NAVIUS

DATE • Tuesday, 2 November, 2004

SUBJECT • NSA-U3's Schematic Diagram modified

1. Backup Battery Schematic Diagram – Add Voltage Detector and Capacitor

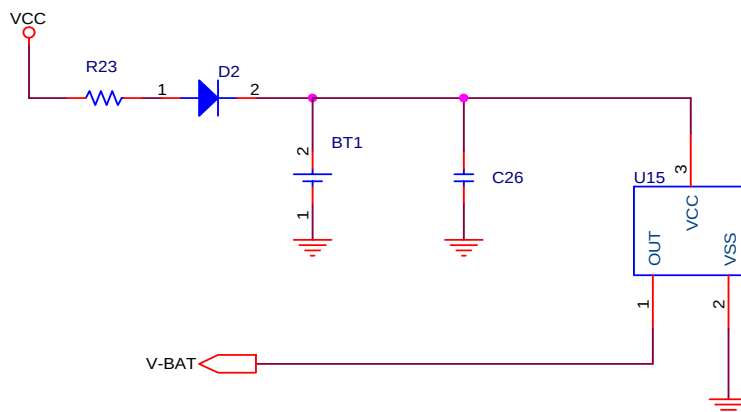
1) Conventional

2) Modified

2. USB Driver - Changed PL2303(shortage) to PL2303HX

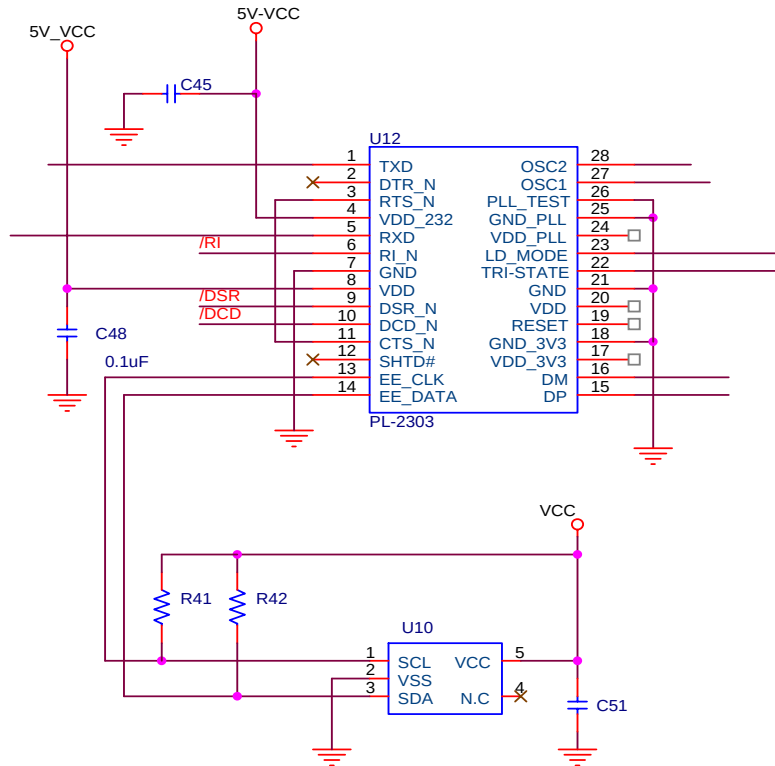
- Add Resistor at the EEPROM

1) Conventional

2) Modified
